**1 BUILDING #1 - FOURTH LEVEL**  
 SCALE: 1/8" = 1'-0"

**Legacy at Jones Farm Phase 2**  
 HUNTSVILLE, ALABAMA  
 AN APARTMENT COMMUNITY FOR  
 RBJ BAILEY, LLC

BUILDING PLANS  
 BUILDING #1  
 SHEET NO.

**A2.16**

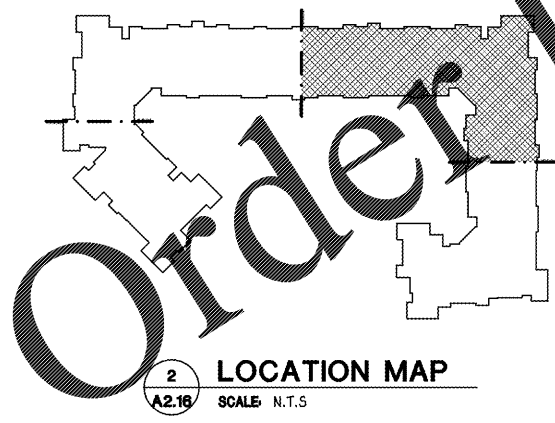
NO WINDOW/DOOR OPENINGS WITHIN 4'-0" OF 2-HOUR WALL EACH SIDE. OFFSET WINDOWS/DOORS TO COMPLY.

NO WINDOW/DOOR OPENINGS WITHIN 4'-0" OF 2-HOUR WALL EACH SIDE. OFFSET WINDOWS/DOORS TO COMPLY.

NO WINDOW/DOOR OPENINGS WITHIN 4'-0" OF 2-HOUR WALL EACH SIDE. OFFSET WINDOWS/DOORS TO COMPLY.

NO WINDOW/DOOR OPENINGS WITHIN 4'-0" OF 2-HOUR WALL EACH SIDE. OFFSET WINDOWS/DOORS TO COMPLY.
